SERVICE BULLETIN

BULLETIN: #2-07

637462 Valve Kit Replaces 350-058-X Valve.

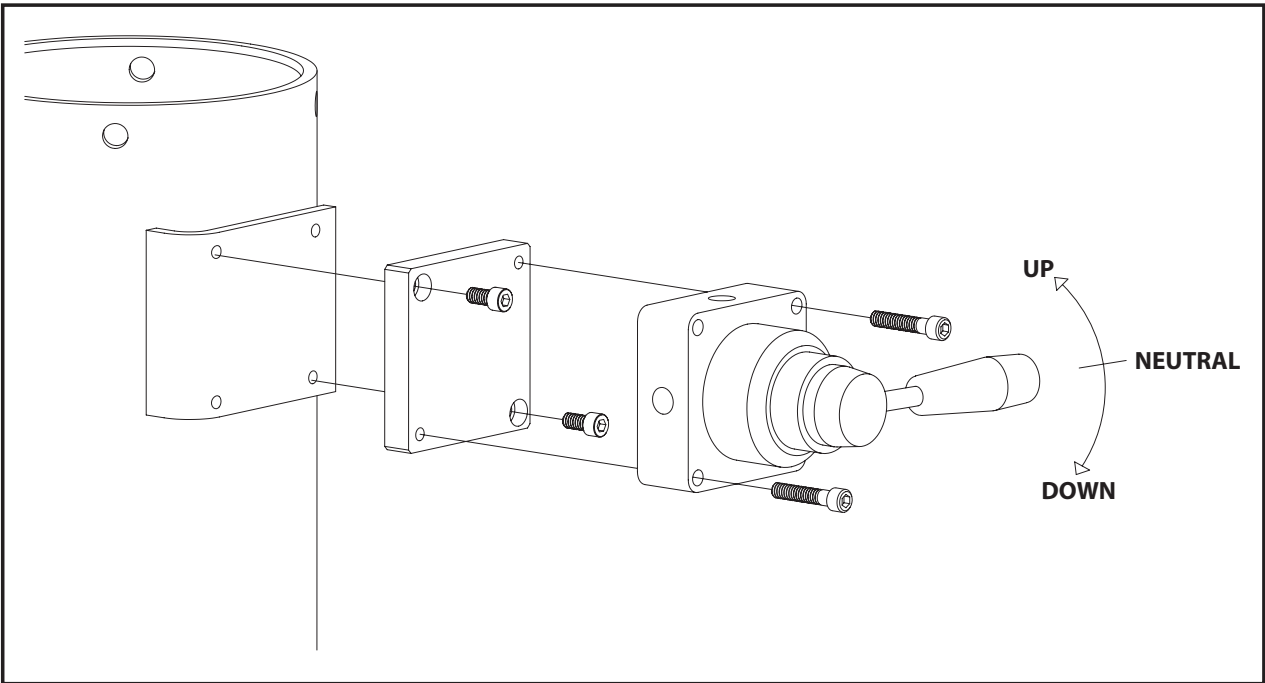
637462 Valve Kit includes:

- 1 - 4-Way Valve
- 1 - Adapter Plate
- 2 - Socket Head Cap Screw (1/4" - 20 x 1/2" long)
- 2 - Socket Head Cap Screw (1/4" - 20 x 1-1/4" long)

Piping Connections (port marking on valve body)

- Port A - Hose connection to top of elevator cylinder
- Port R - Exhaust
- Port P - Air inlet connection
- Port B - Hose connection to bottom of elevator cylinder
